RE: Block F Rezoning/OCP Amendment Application Response to UEL Letter dated Feb 6, 2014

Re: Block F Development Approval Response from UEL dated February 6, 2014

To:	Steve Butt	From:	Steve Jeffares
Cc:	Gordon Easton	Date:	March 5, 2014
Project #:	Block F, 545-40	File:	12-125-03
Re:	Musqueam Block F – Development Approval Information

DATE: March 26, 2014
PROJECT: 4912-01
NO:
PROJECT: Block F Development, University Endowment Lands
SUBJECT: Response to UEL Staff Comments Regarding the Transportation Assessment Report

SHEET TITLE:
CONCEPTUAL
TYPICAL SECTIONS

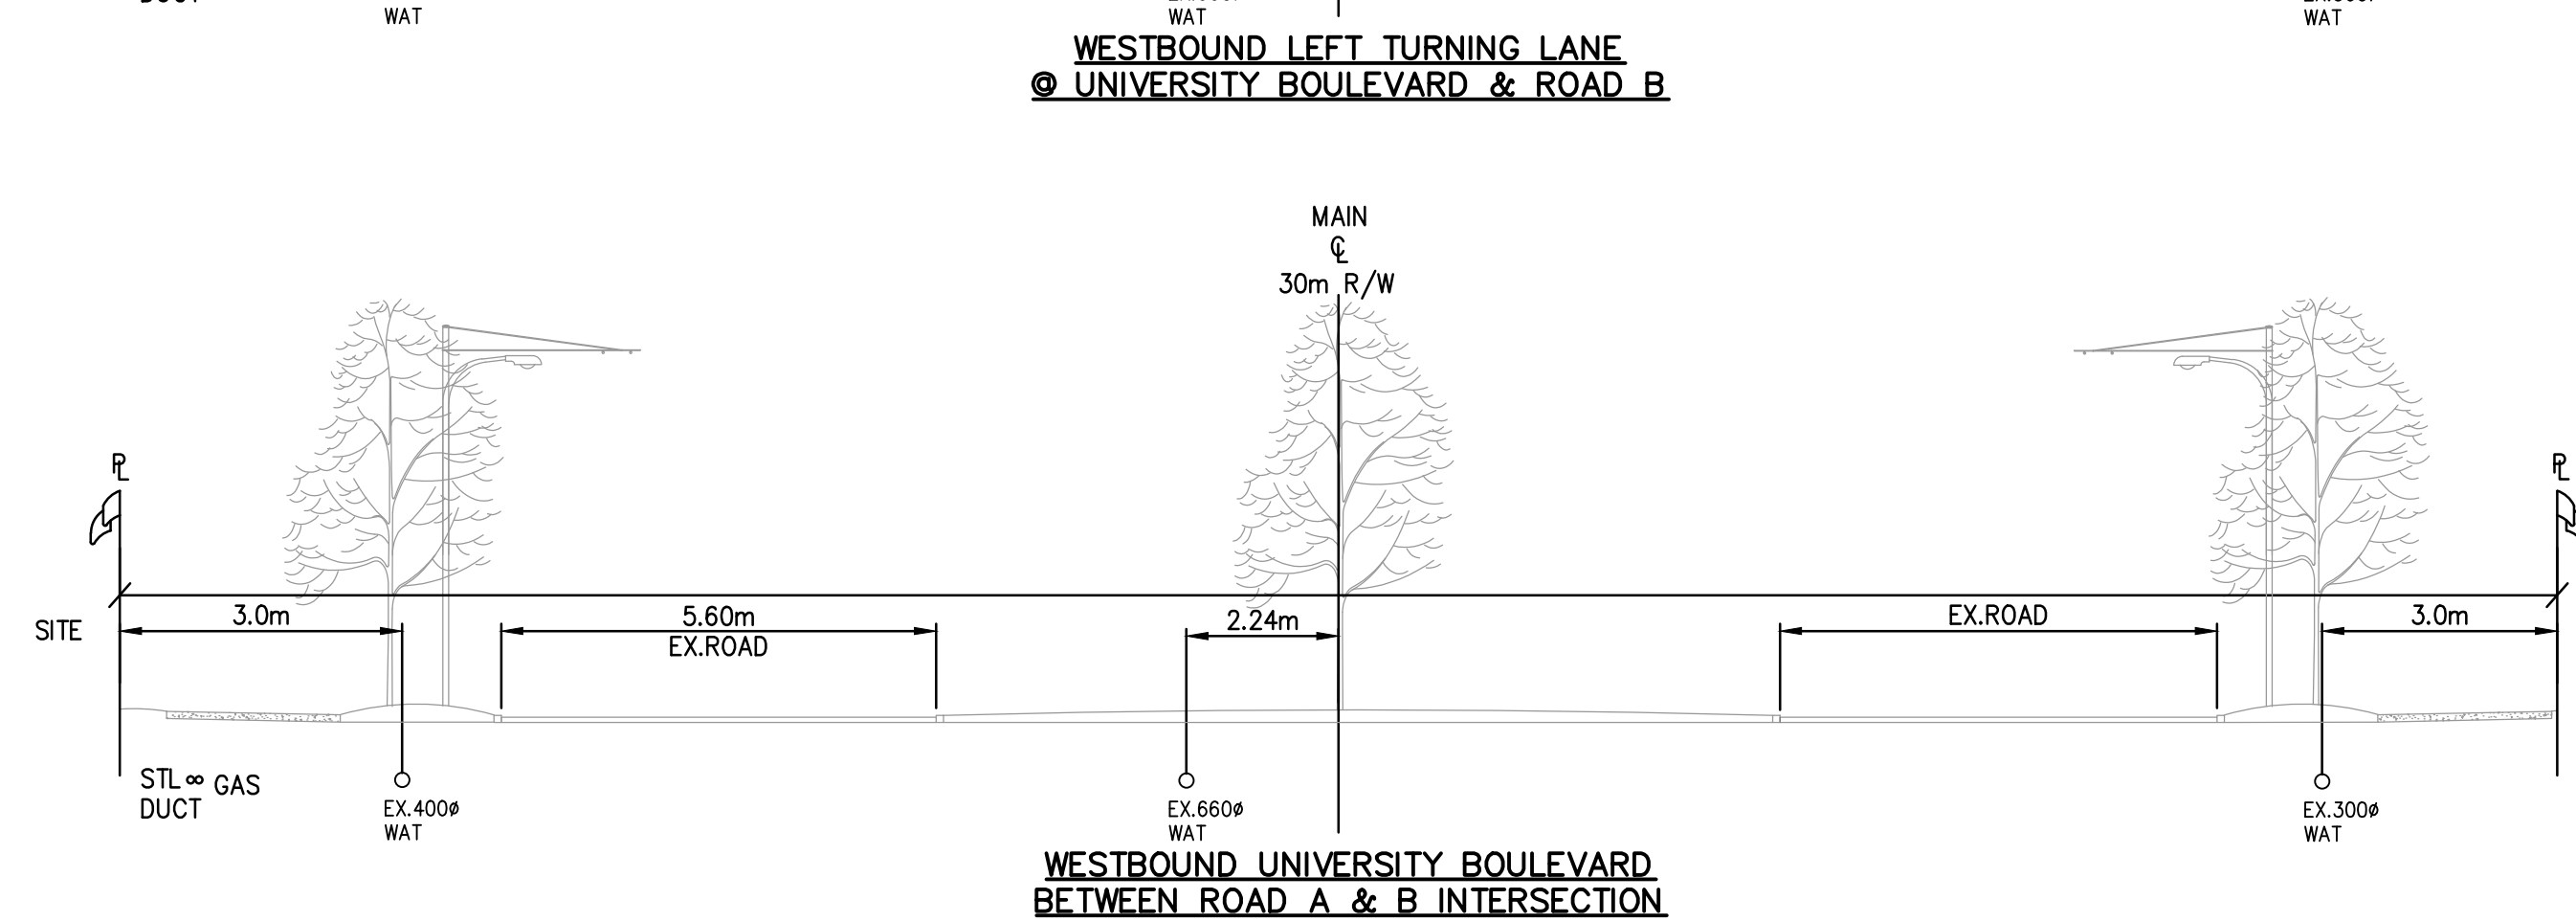
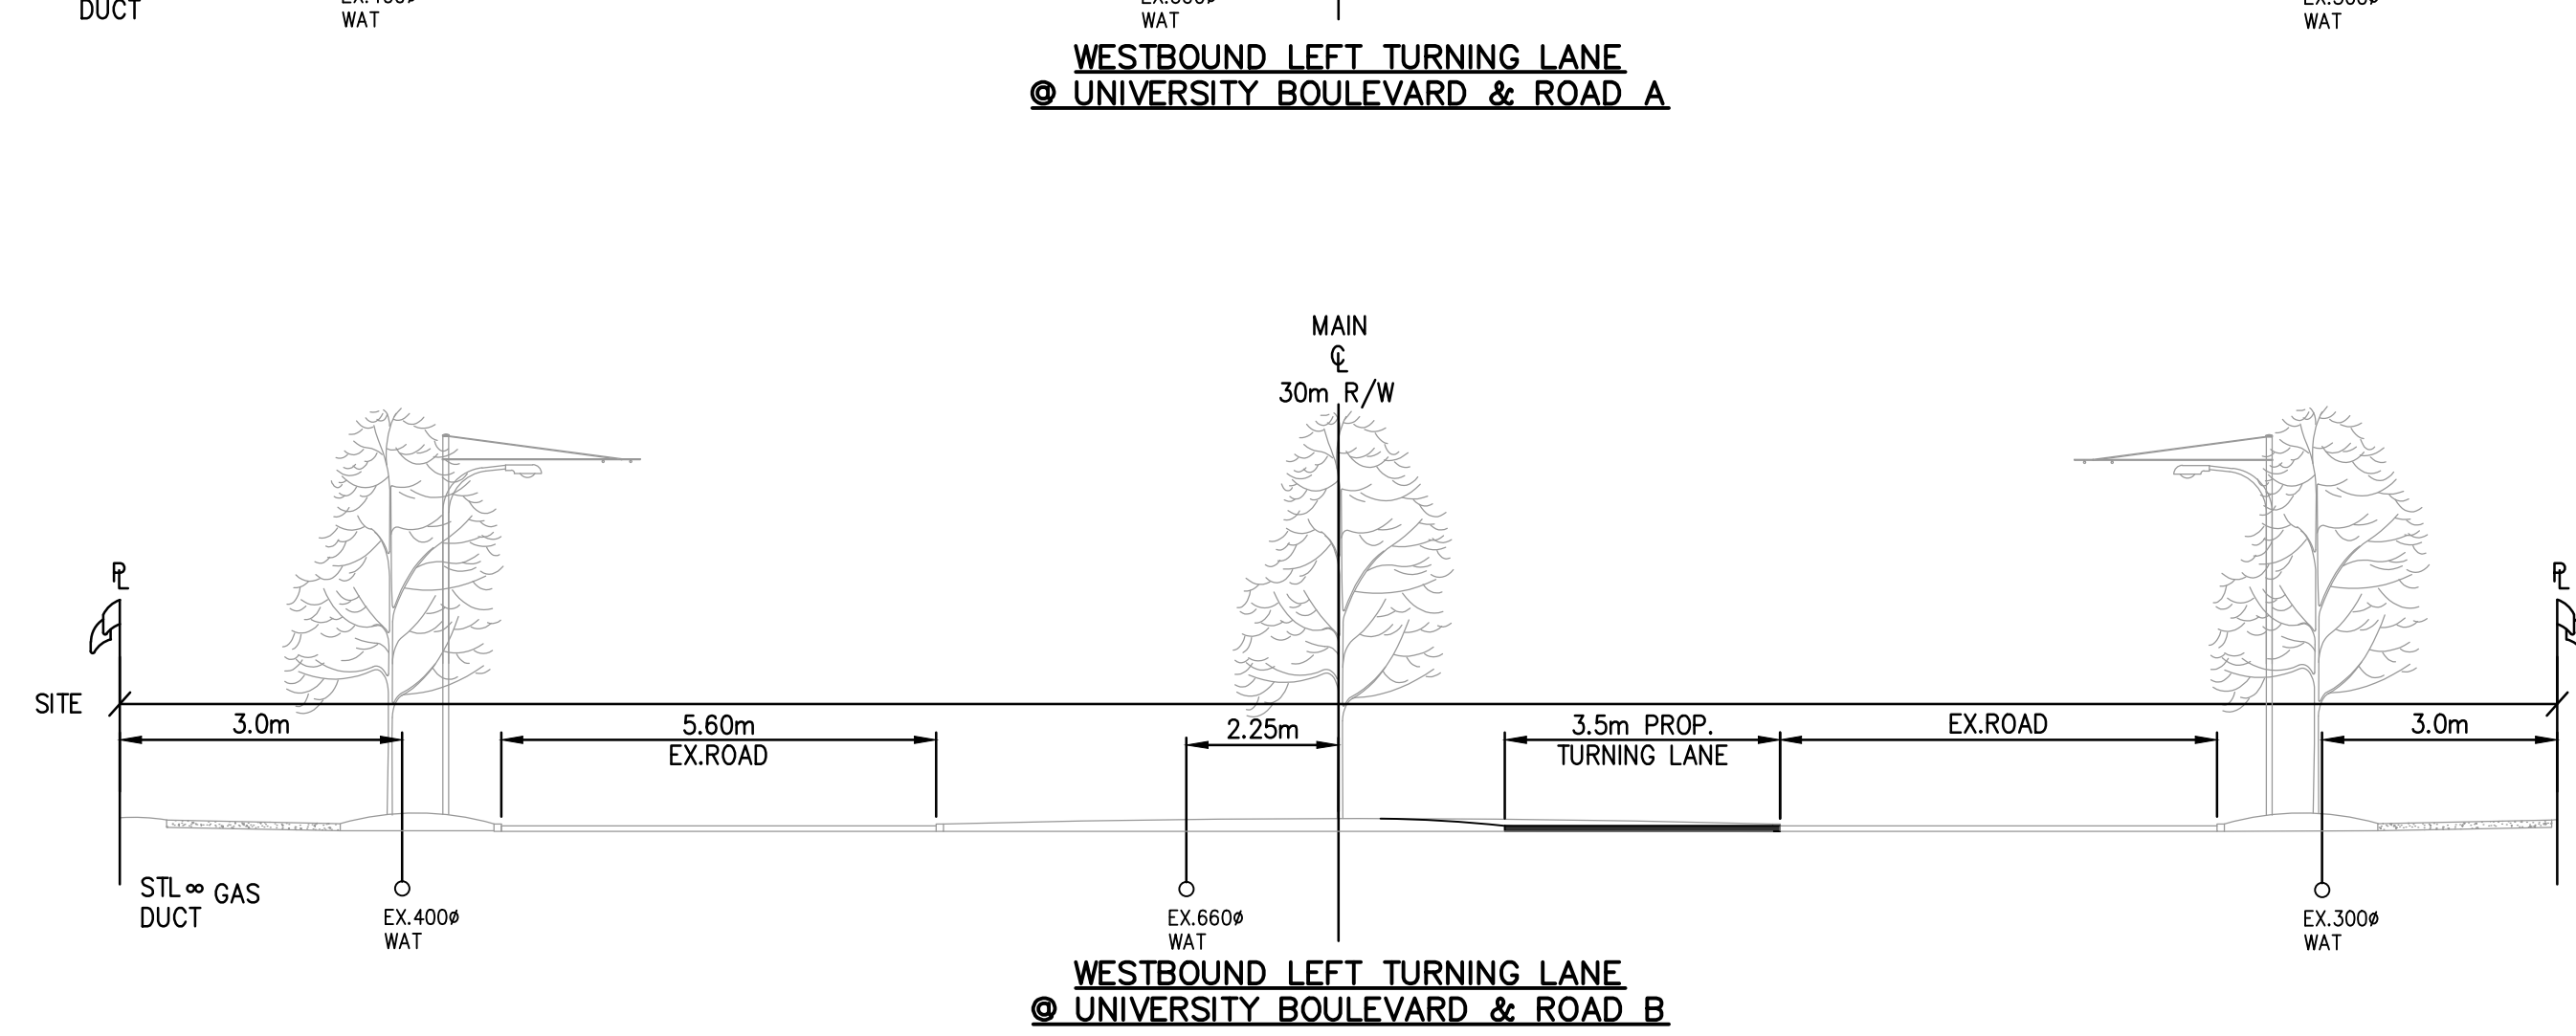
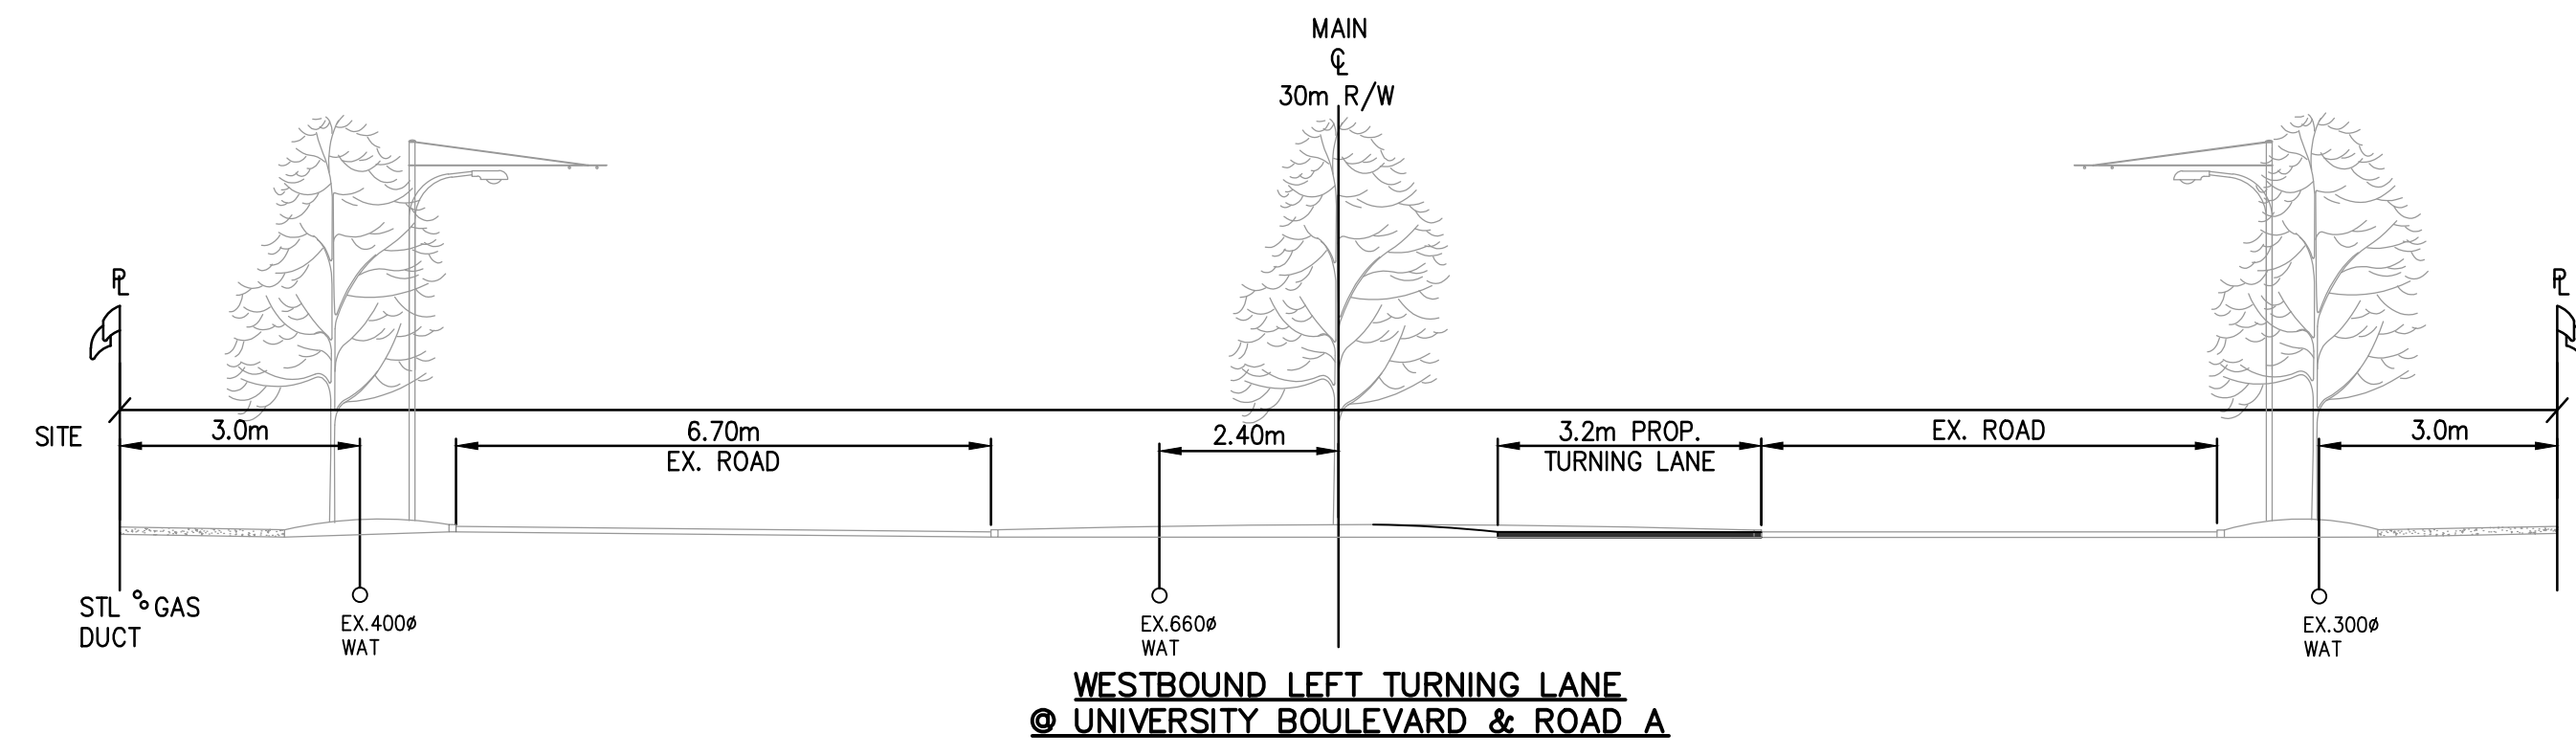
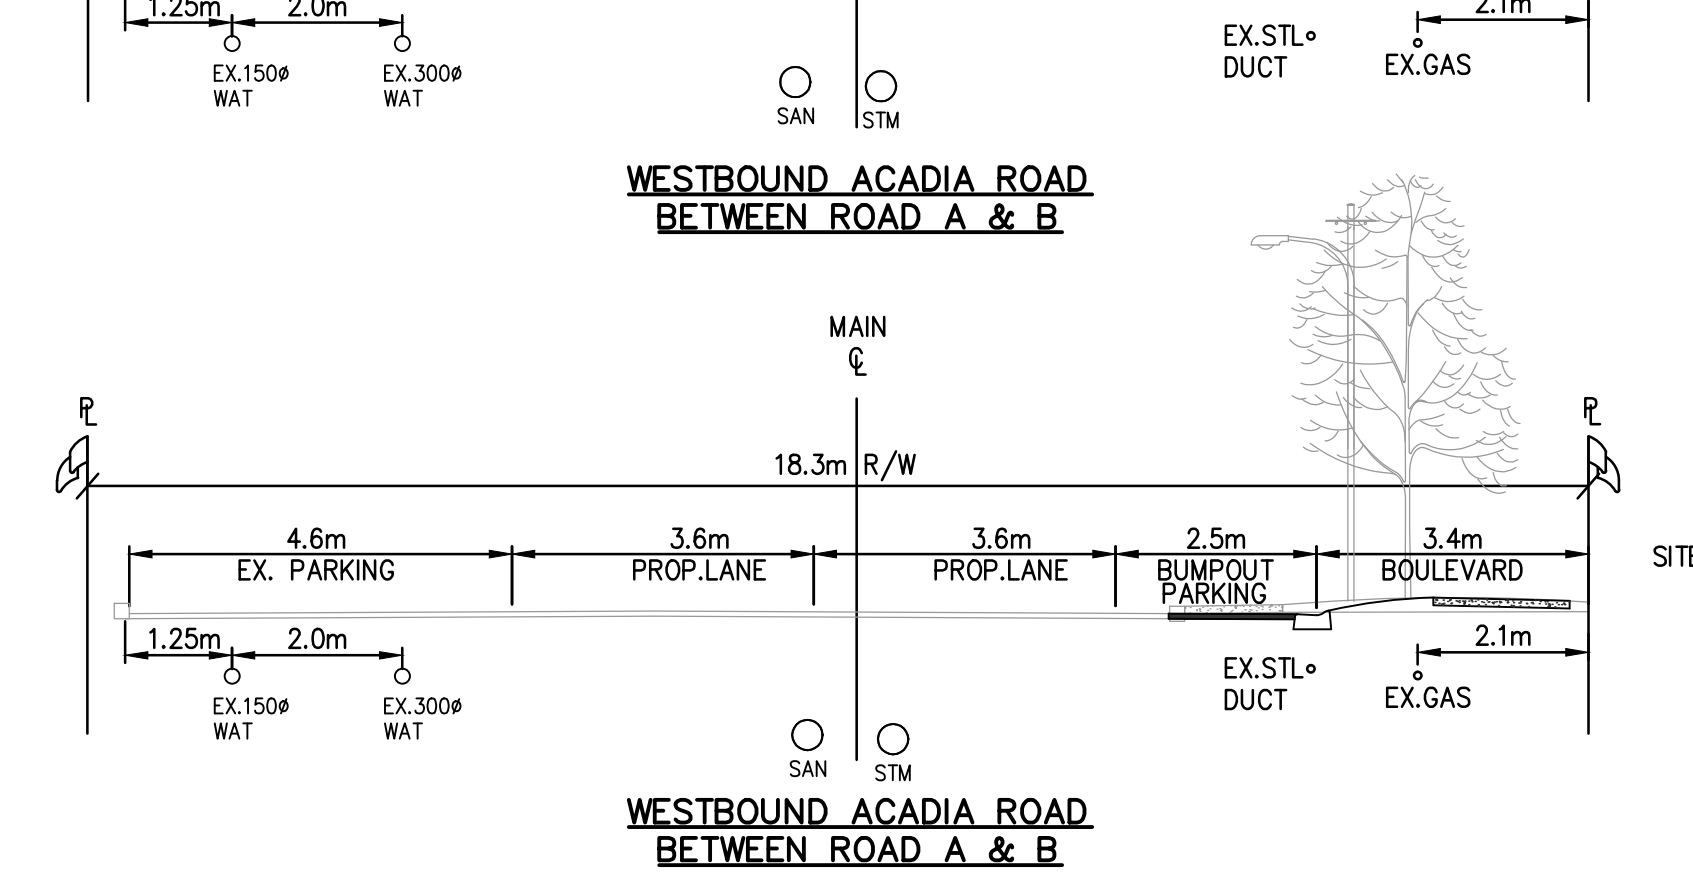
3f. Road Cross-sections: Please provide detailed cross-sections with complete measurements for both University Blvd. and Acadia Rd. To demonstrate that there is sufficient width for what is proposed. Please show the "worst case scenario" (e.g. where there is the least amount of available setback). Please provide a larger, to-scale version of Figure 2.17 that shows conceptually sufficient measurements to assess the feasibility of this plan.

The Landscape Plan has been updated. Also, for detailed measurements, please refer to the updated Civil Plan. Based on the Landscape and Civil plans, it is confirmed that there is sufficient width to accommodate the proposed cross-sections.
